February 15, 2016

ND-16-0083
10 CFR 50.90

Southern Nuclear Operating Company
Vogtle Electric Generating Plant Units 3 and 4
Request for License Amendment:
Update of Common Qualified (Common Q) Platform
Software Program Manual and Topical Report (LAR-15-017)

Figure A3-1, “Exhibit 2-1 Design/IV&V Team Organization”

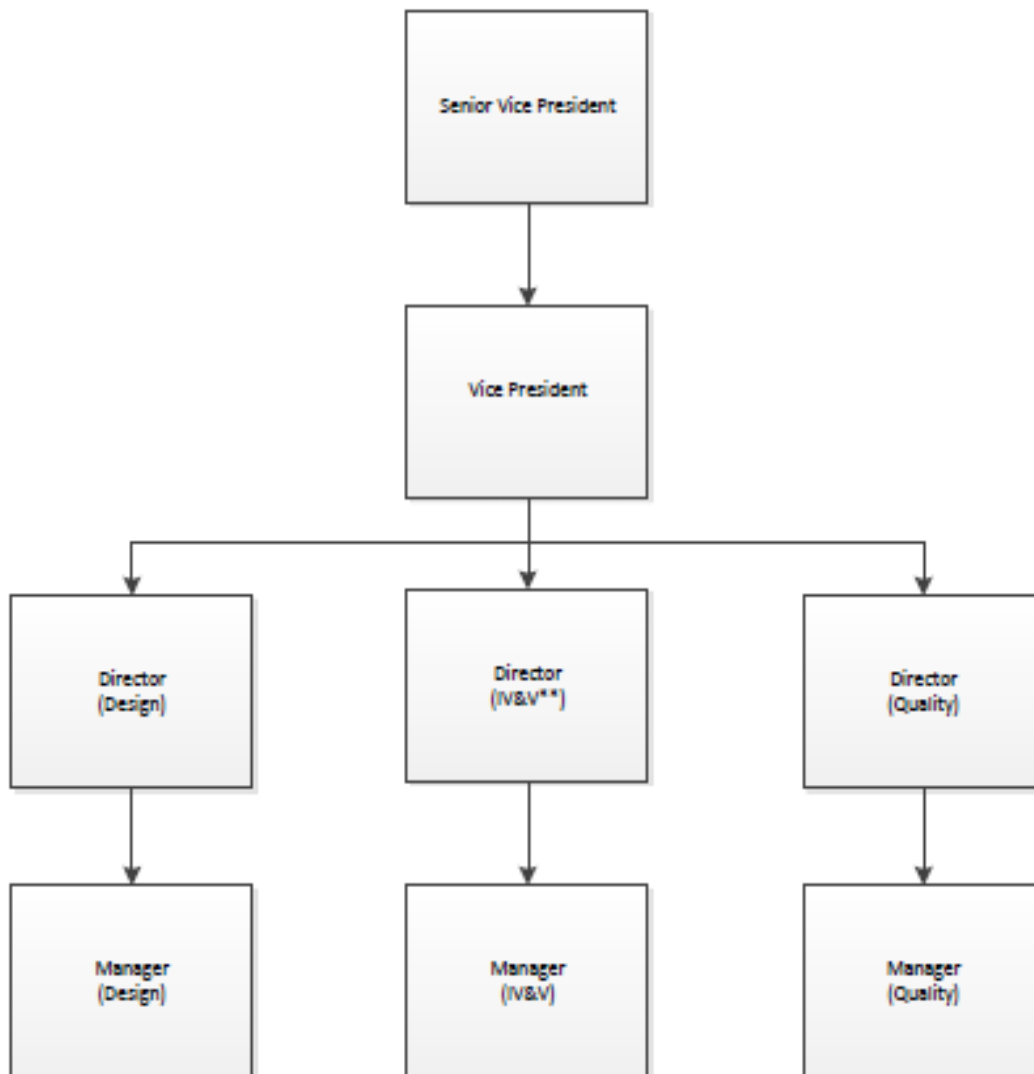
- The responsibility for the performance of system testing was changed from the design team to an independent team.
- The roles and responsibilities for producing the Requirements Traceability Matrix (RTM) were clarified.
- A Test Plan, Computer Security Plan, and Installation Plan were added.

*This example organization chart shows the minimum level of separation required for the Design, IV&V, and Quality Teams

Figure 7.1-1

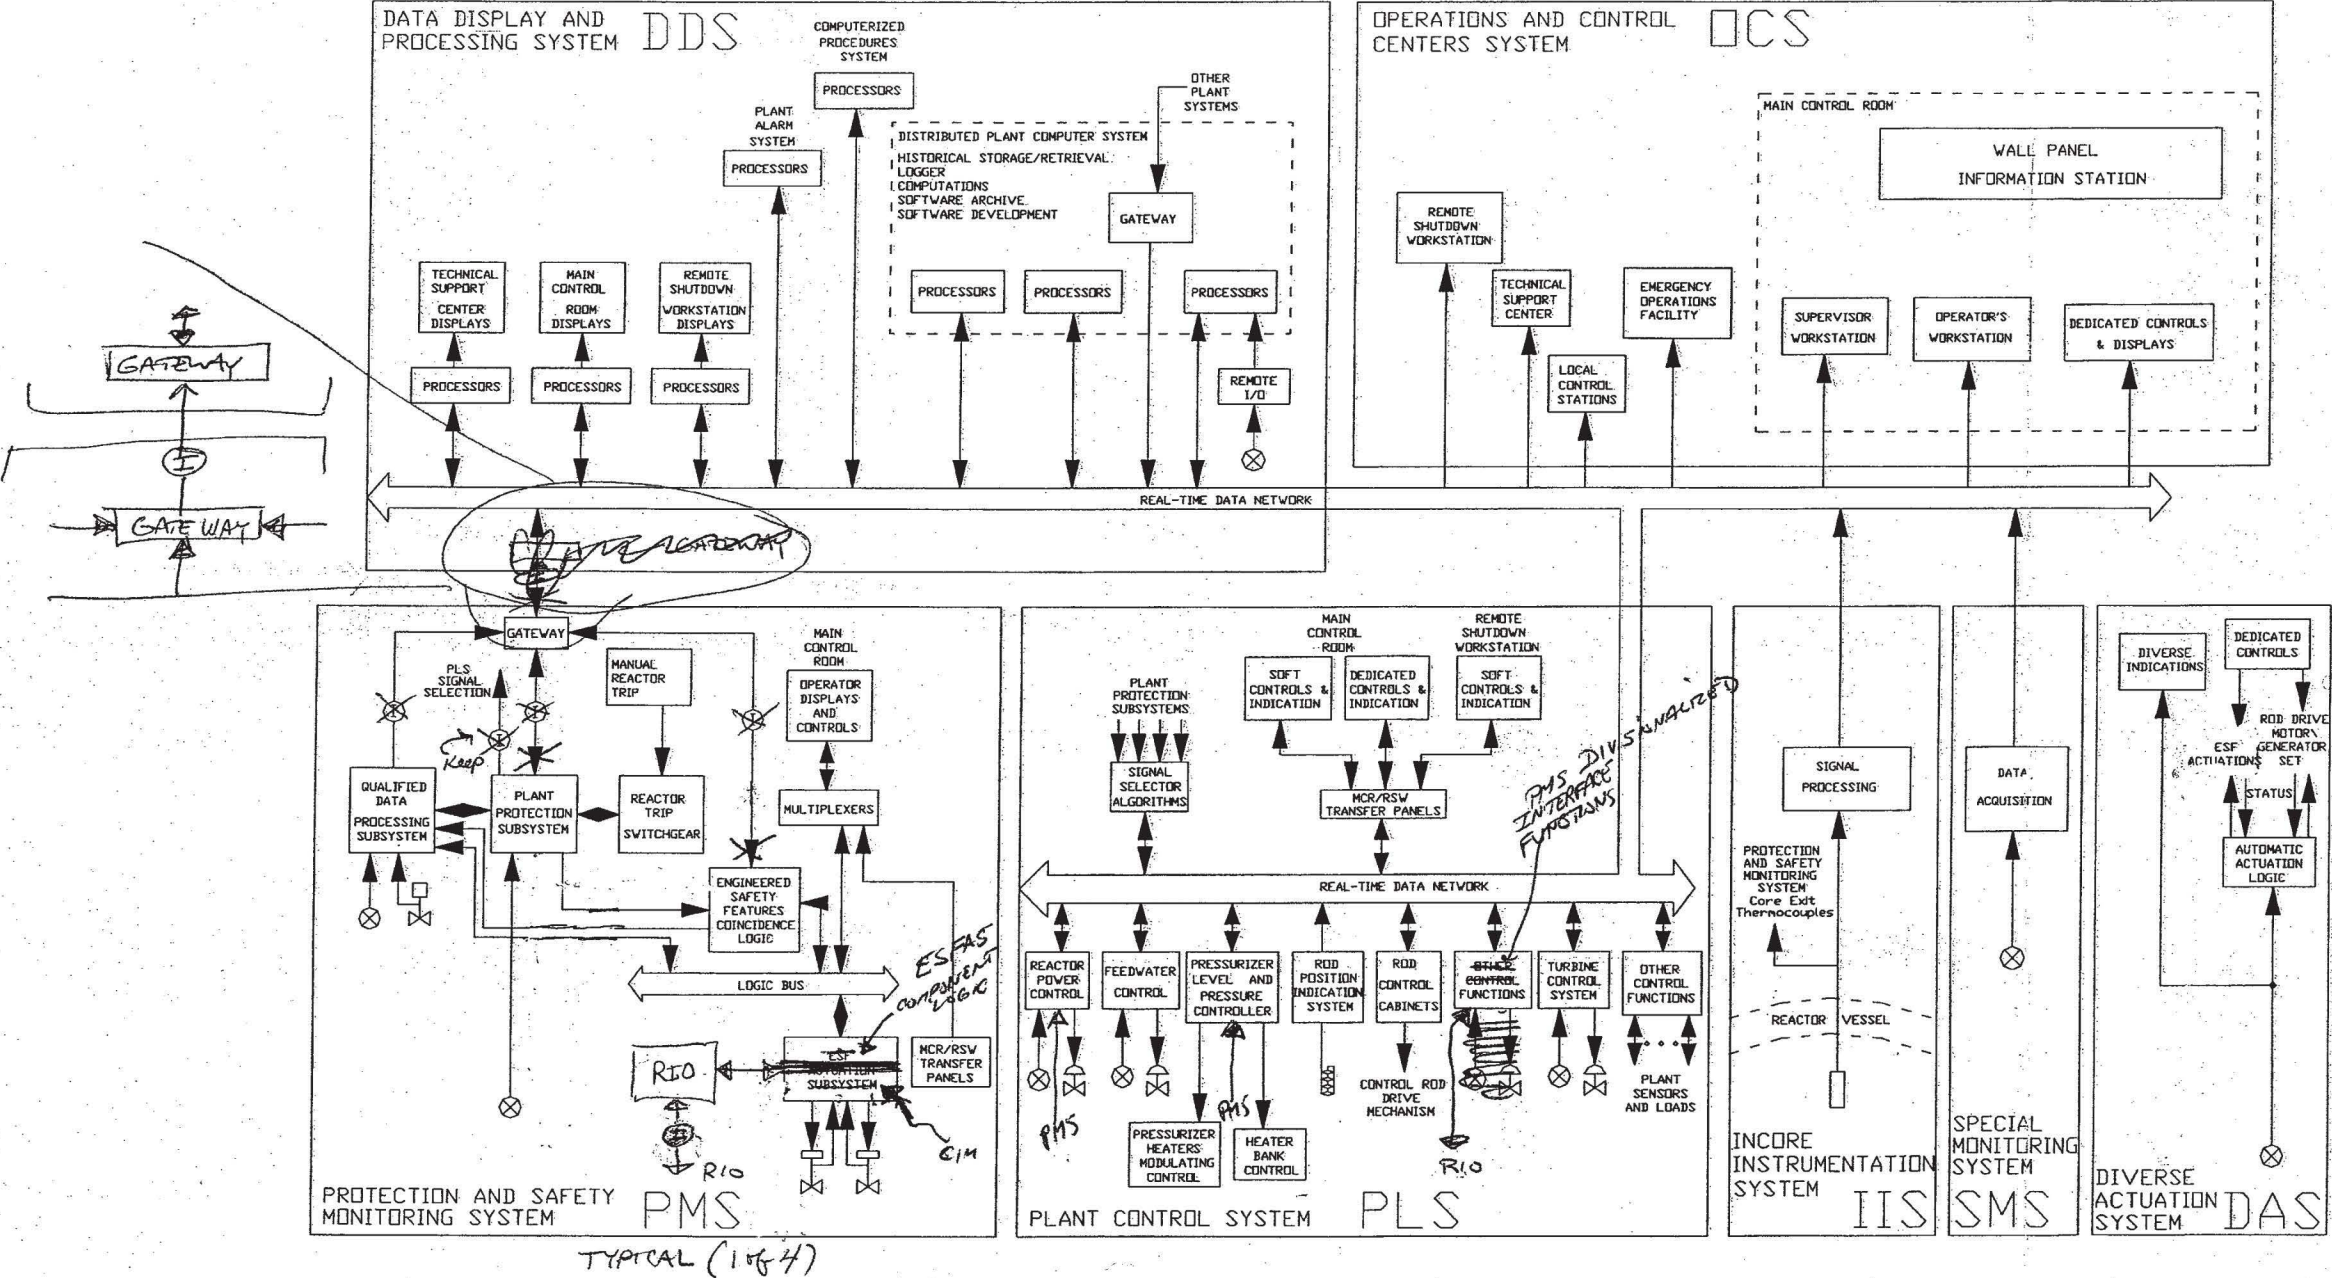
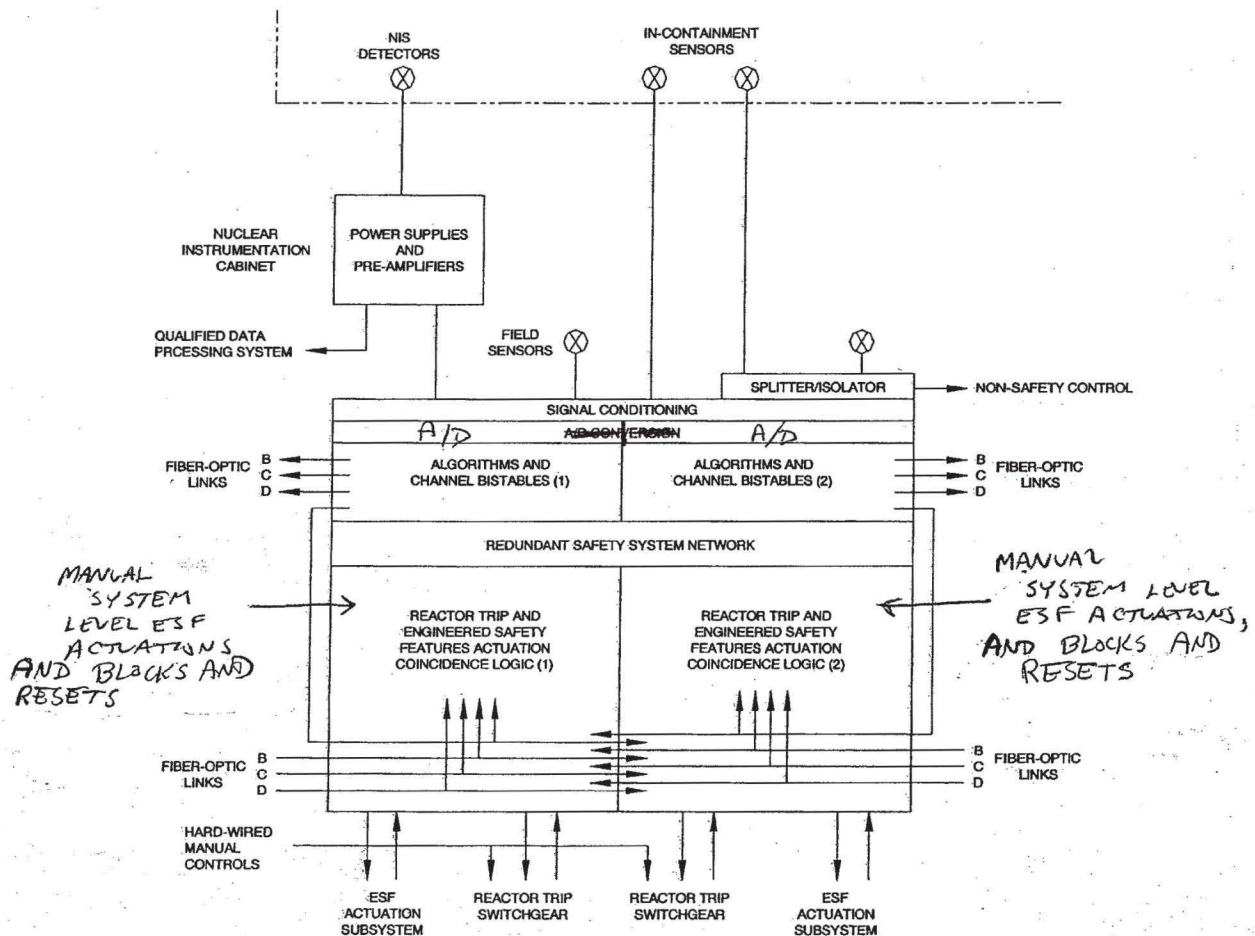
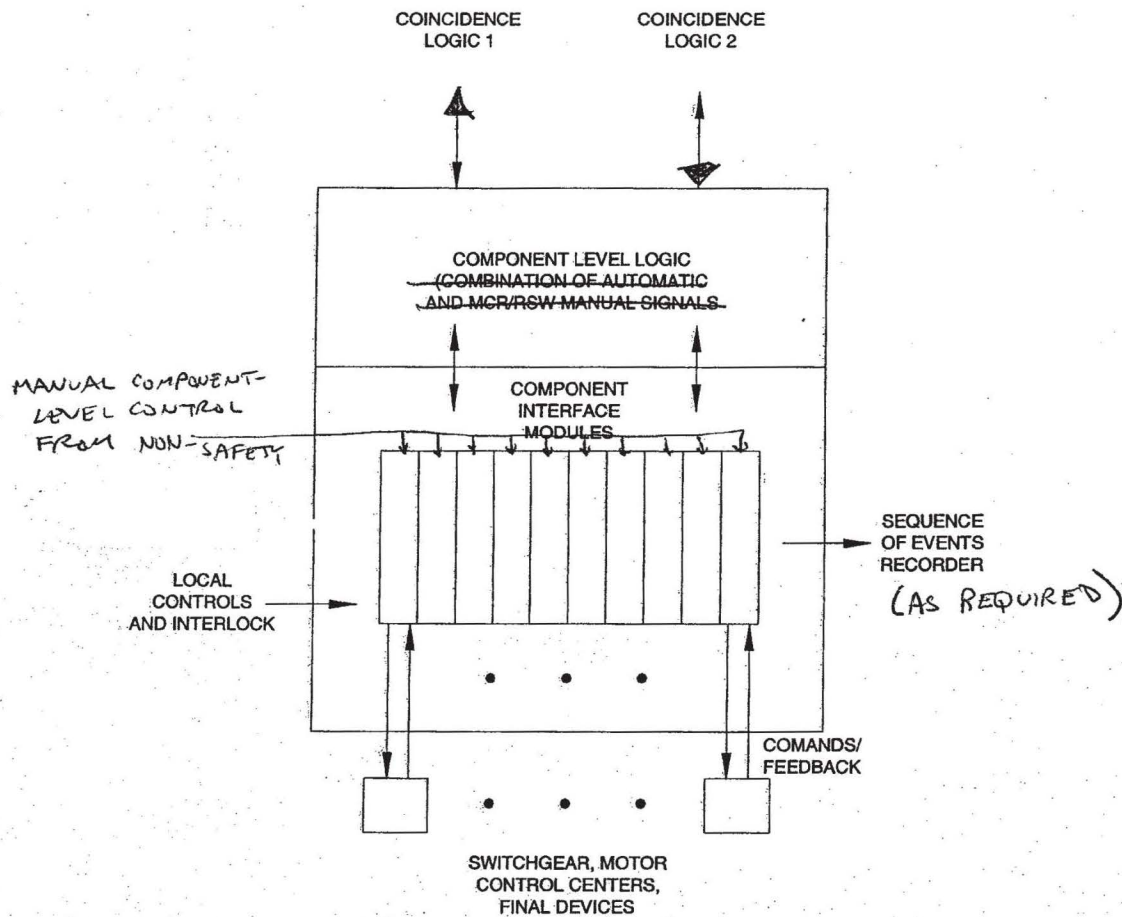
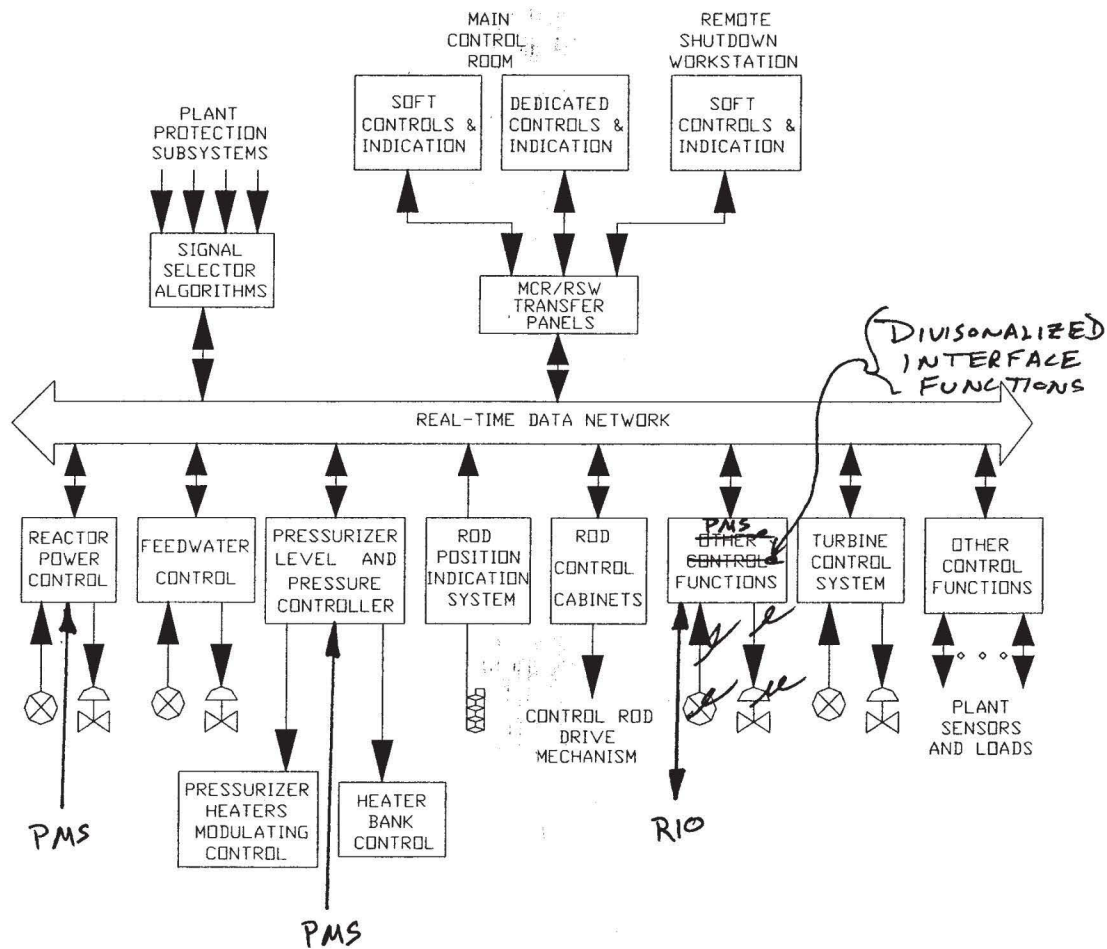
Revise Figures 7.1-1, 7.1-2, 7.1-3B, 7.1-9B, and 7.1-10 as attached.

Figure 7.1-2

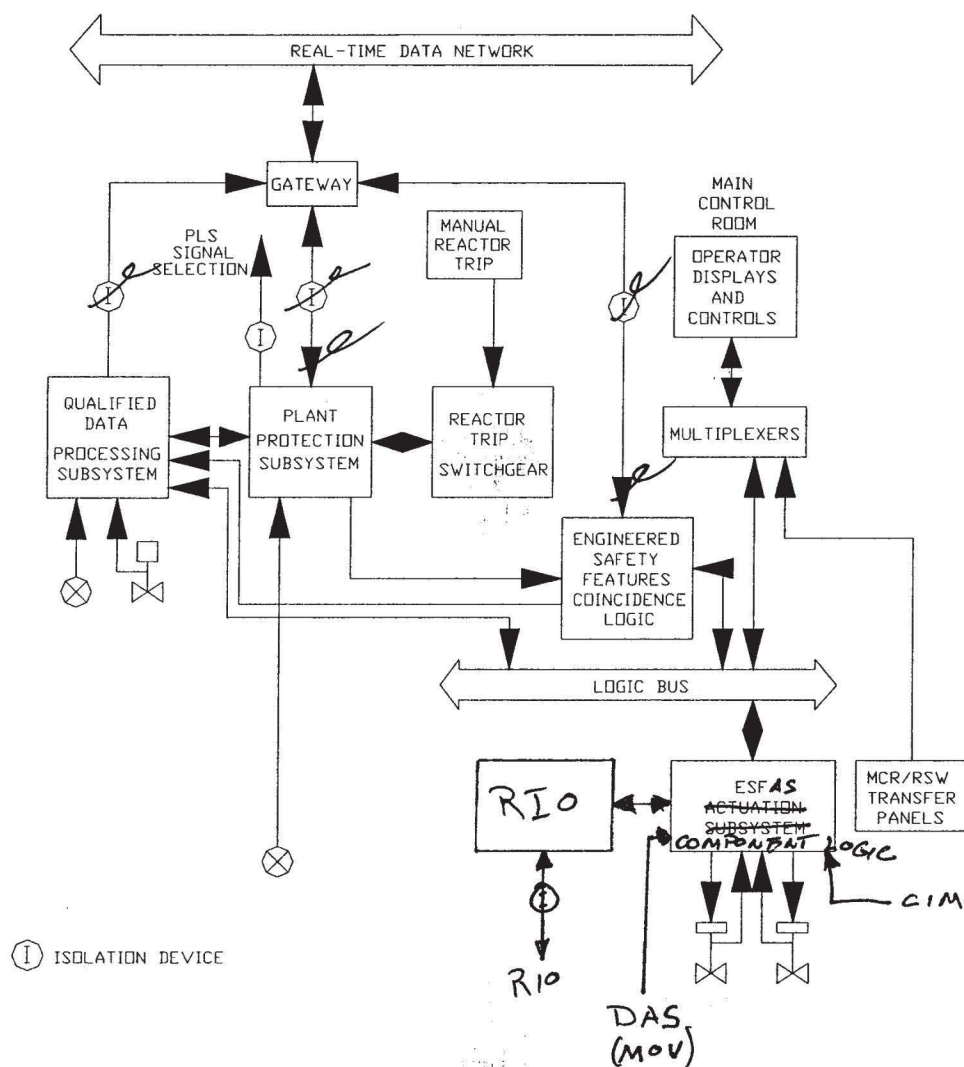
- Add a note to WCAP-16674 (Reference 25) to identify that modifications are provided in UFSAR Appendix 7A.
6. UFSAR Figure 7.1-2 is updated to replace the original citation to the non-proprietary version of the SPM with a citation to the proprietary version of the SPM.
 7. Section 7.2.4, "References" is revised to add a note to WCAP-16592 (Reference 4) to identify that modifications are provided in UFSAR Appendix 7A.

9. UFSAR Section 7.1, Figure 7.1-2, “Common Q Standard Process and AP1000 Project-Specific Documents”:

Exhibit 2-1
Westinghouse Organization Chart*

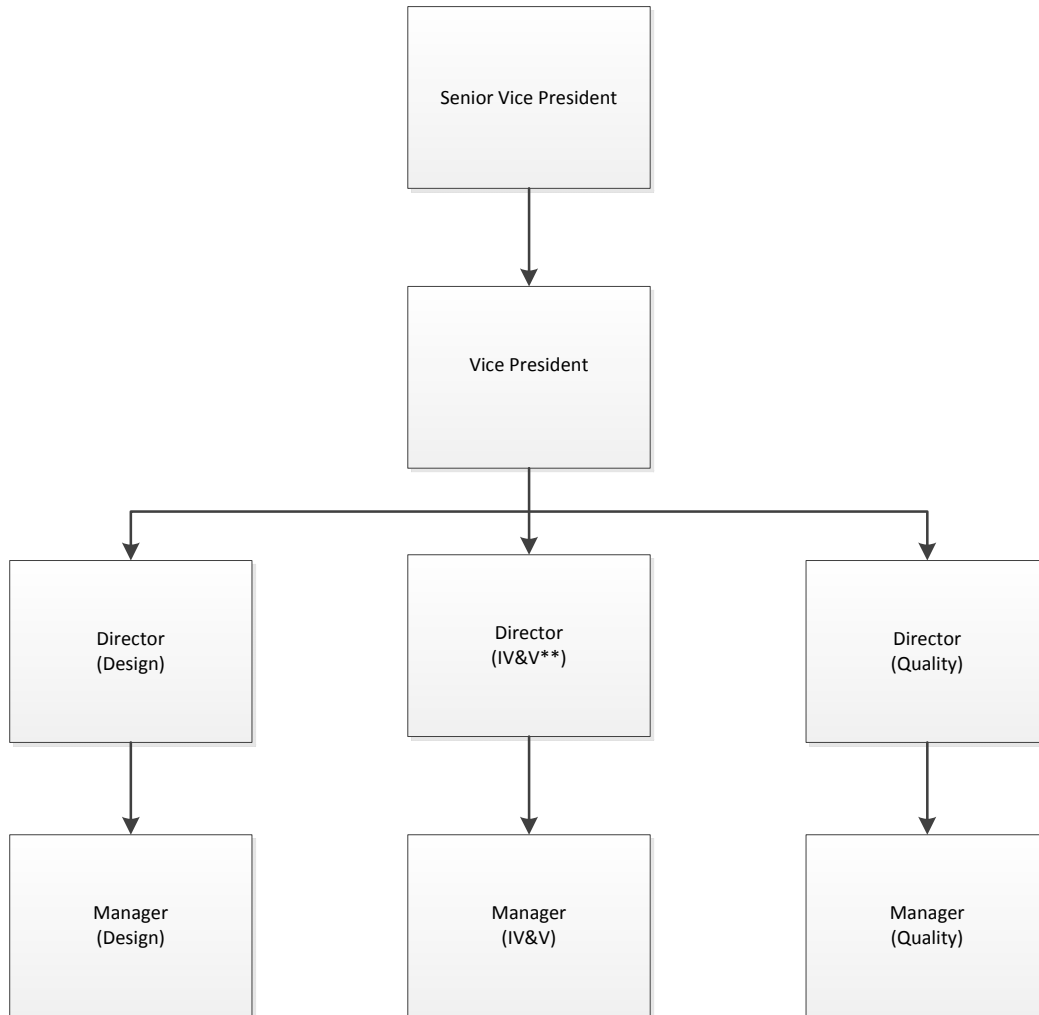
**System level validation testing is performed by another group, which meets the same level of independence as the IV&V group depicted in this organization chart
